## Accessibility Survey

### City of Downey Brookpark Road - Lindsey Avenue to Eglise Avenue

**Disability Access Consultants**

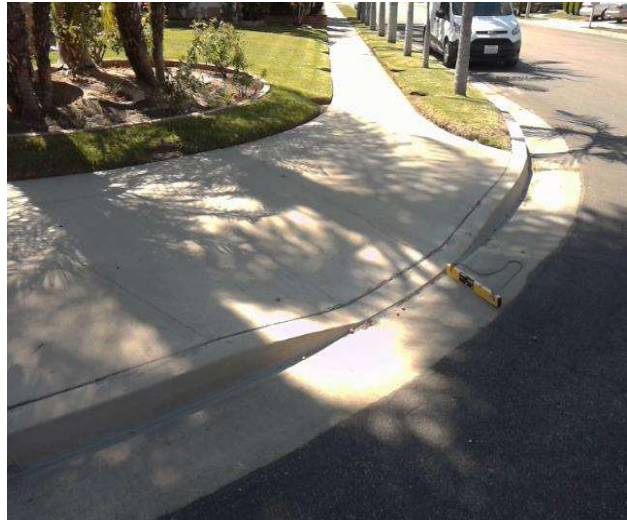
**On-Site Finding** Not Beveled

Patch the transition area at the bottom of the curb ramp so that the transition is flush and free of abrupt changes.

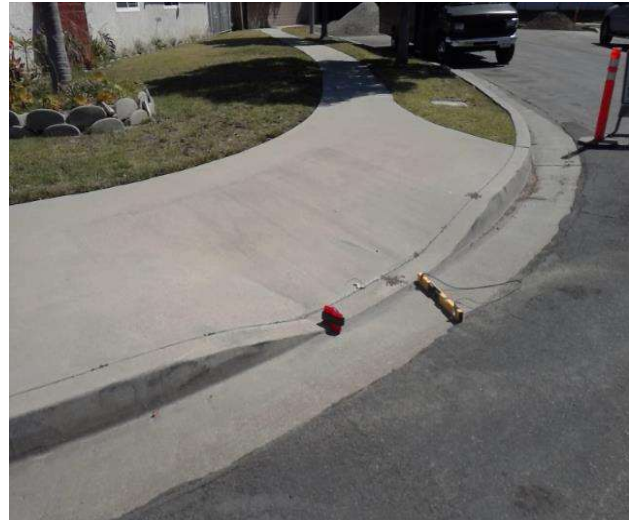
The bottom landing of the curb ramp is on the street, and the slope of the bottom landing is not compliant.

**On-Site Finding** 7.10 percent

Ensure the bottom landing slope is compliant and provides a smooth transition.

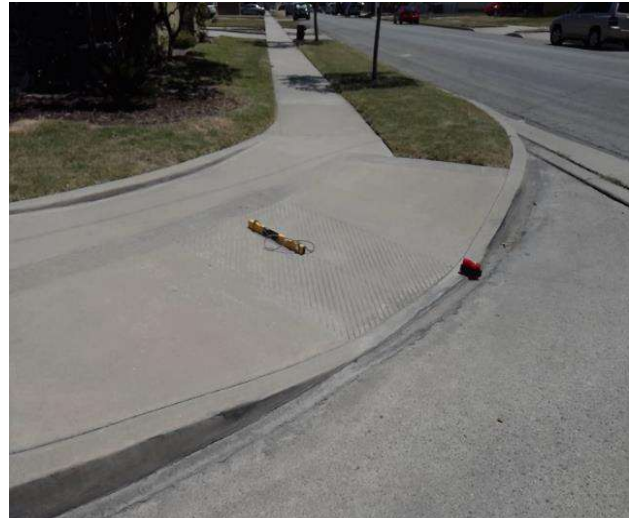
The running slope is greater than allowed.

**On-Site Finding** 11.20 percent

Provide a compliant curb ramp.
